**PROPOSED ESKOM NUCLEAR POWER STATION
AND ASSOCIATED INFRASTRUCTURE**

ENVIRONMENTAL IMPACT ASSESSMENT (EIA: 12/12/20/944)

**COMMENTS ON
DRAFT ENVIRONMENTAL IMPACT ASSESSMENT REPORT**

(Volume 01: 09 May 2011)

P:\J27035 - Nuclear Power Station 116\TransReview of Transport Specialist Study\Jan 2012\Images\Cityscape\Figure 9.5_2012_Eastern Bypass Alternatives.dwg | R:\DAMS | 05/07/2012 10:43:04 AM

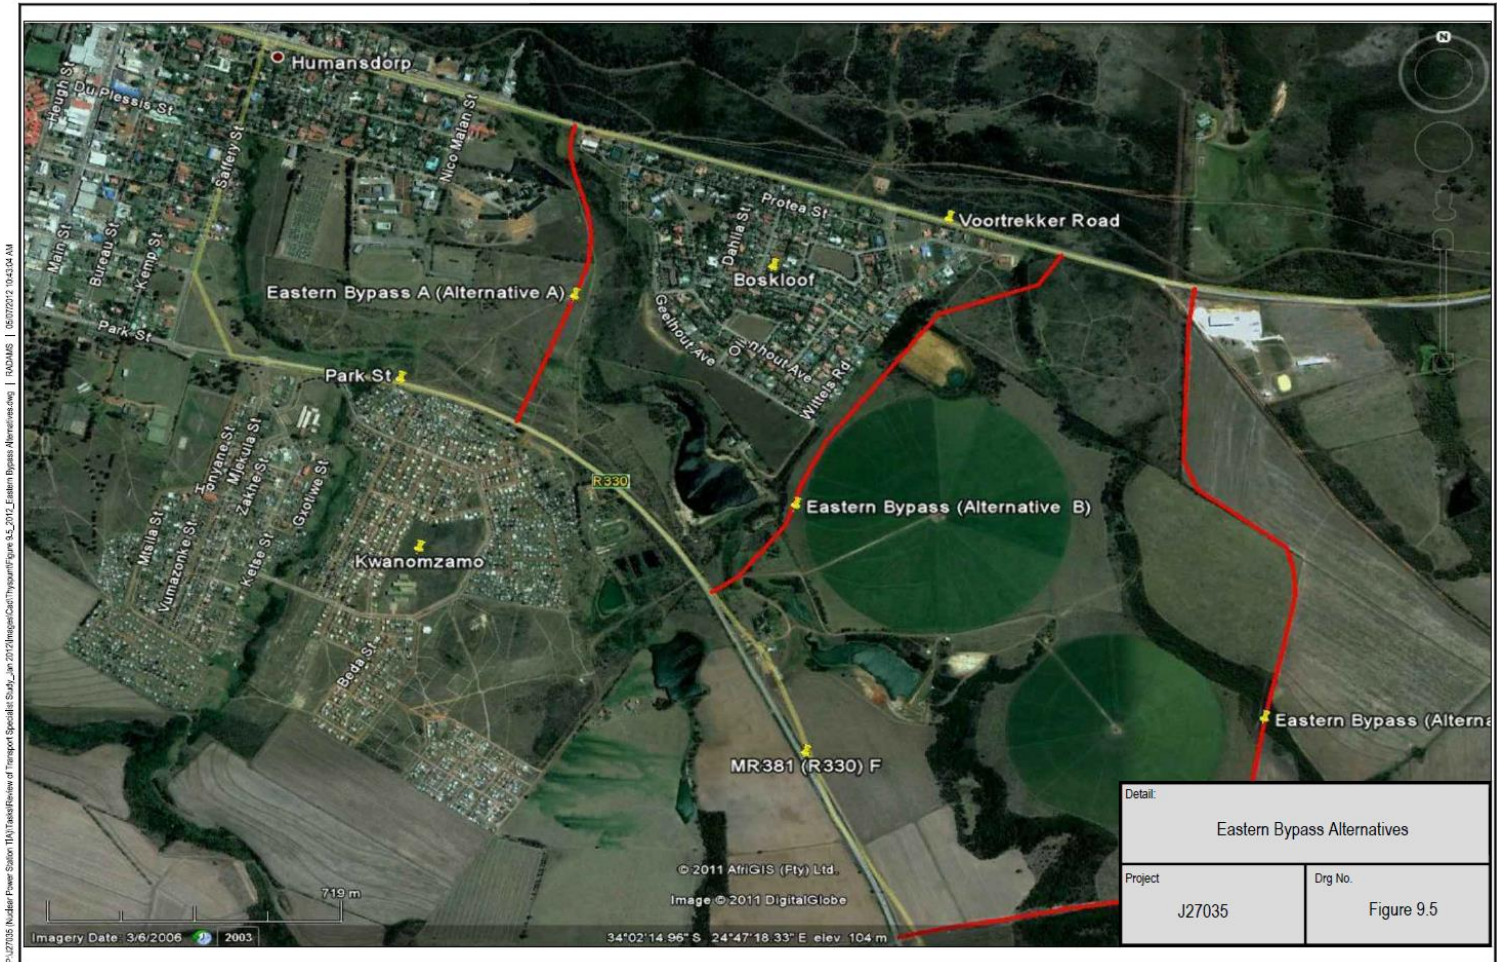
Arcus Gibb states that they have found a route for their heavy vehicles to by-pass Humansdorp during the construction phase. The “new” route uses Saffery Road, which runs through a residential area and is already used extensively by traffic avoiding the Humansdorp main road, en route to SFB and CSF.

Response 7:

Your comments are noted. Similar concerns from the public around Humansdorp area up to St Francis have been raised and acknowledged regarding the use of Saffery Road. As such the Transport Specialist study was revised to consider other alternative routes (see figure below). The revised report recommends that the main street through Humansdorp and Saffrey Street be bypassed. New transport roads for abnormal load vehicles were therefore considered and three alternate bypasses were investigated, as shown in the figure attached. All three alternatives are proposed new roads that run along existing land boundaries between farmland.

Alternative A directly links between Voortrekker Road (MR389) and Park Street (MR381) and is 850m in length. The beginning of Alternative A crosses the Boskloof Valley and the rest of the route will be constructed on Municipality land.
